ADDENDUM 03

PROJECT:	Exeter Twp ESC	MWS PROJECT NO:	25-049
ADDRESS:	70 Gibraltar Road Reading, PA 19606	ISSUE DATE:	10/23/2026*

PATIO WALL
NOT TO SCALE

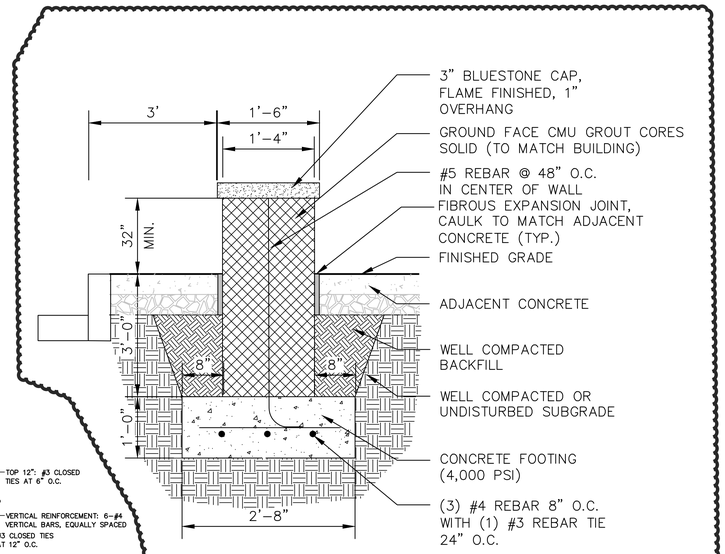
4.) Civil Detail (Sheet C17) - seat wall detail revised per question 15.

15.) QUESTION: There is a seat wall on the civil drawings that is calling out a 1'-6" wide ground face wall. Can this be changed to 1-4" wide that way it would work with 2 wythes of 8" ground face. See attached detail. (DT-03 {C17})

RESPONSE: Yes, change the seat wall to 1'-4" wide and cap to 1'-6".

I-2B.3.1 TO I-2B.3 W/SNOUT

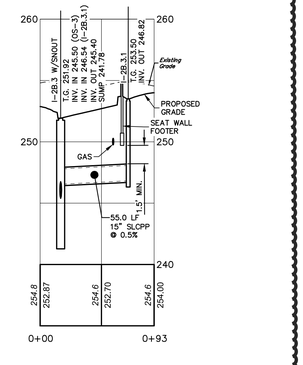
3.) Storm Profiles (Sheets C107 & C207) – Profile of I-2B.3.1 to I-2B.3 added.

7 TRENCH DRAIN DETAIL
1 1/2" = 1'-0"

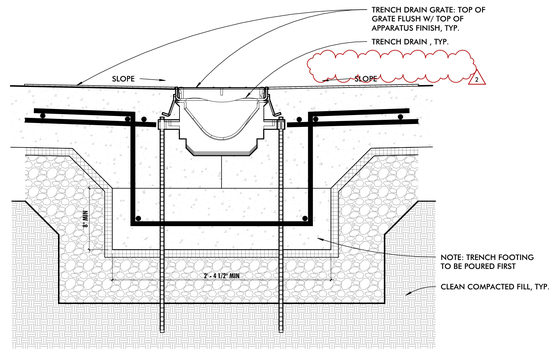
1.) A404: In detail 7 the radiant tubing verbiage was removed.

EXETER FIRE DEPARTMENT · APPARATUS BAY WATER TREATMENT ROOM

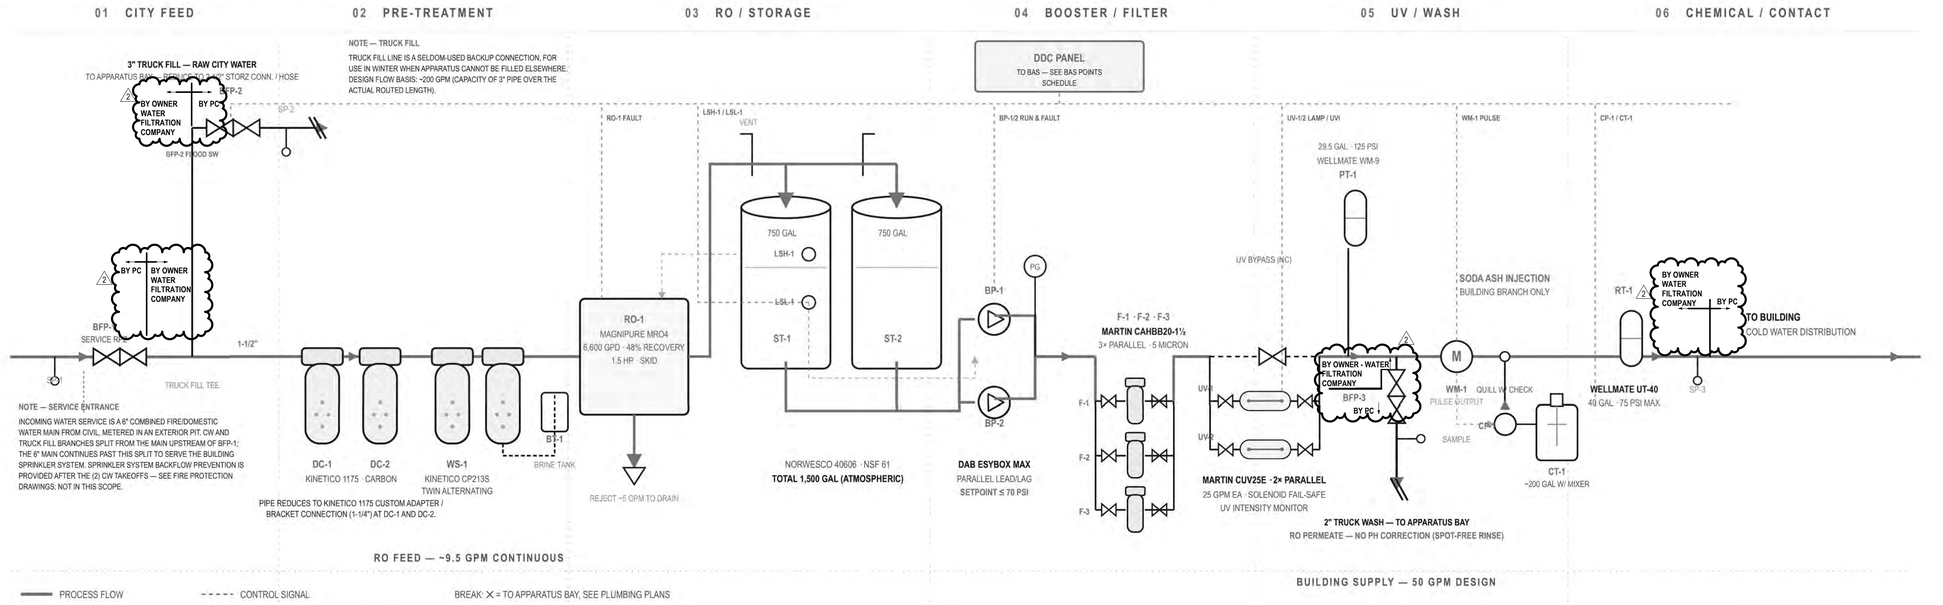
Drawing P6.03 – is any of this equipment furnished by the owner?

RESPONSE: PEX is not acceptable. P603 has been updated to show PC scope vs Owner's Water Filtration Contractor scope.

1 ELECTRICAL SITE POWER PLAN
1" = 20'-0"

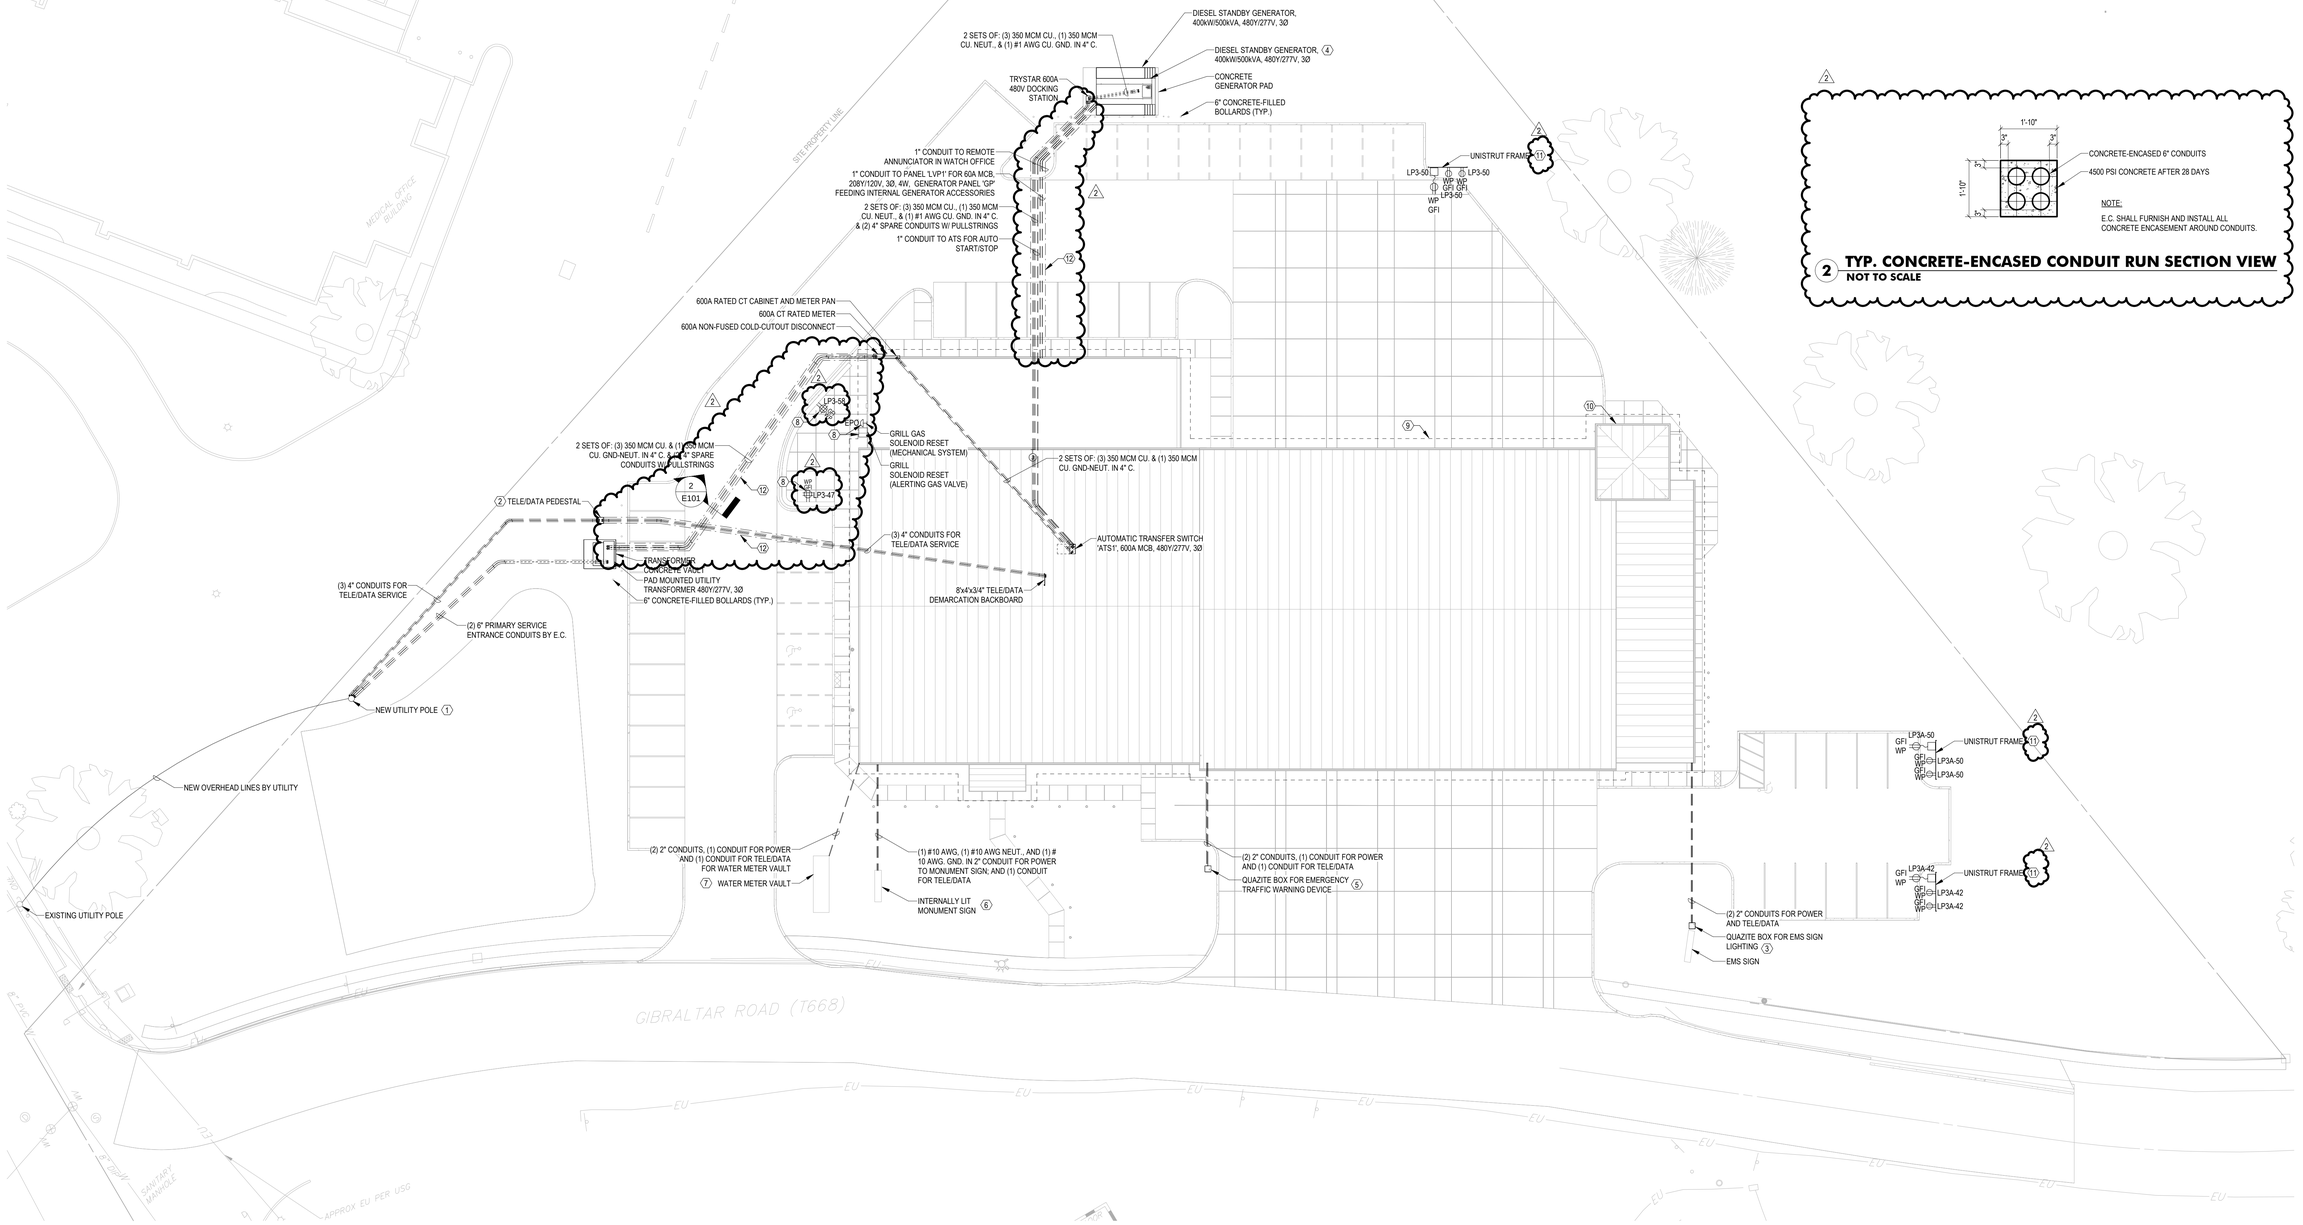
26.) QUESTION: On Drawing E101, Detail 2 shows concrete-encased conduit run section view.

There are no mentions of conduits that need to be concrete encased, does the detail apply to any conduits?

RESPONSE: Site plan will be updated to call out specific concrete encased conduit runs.
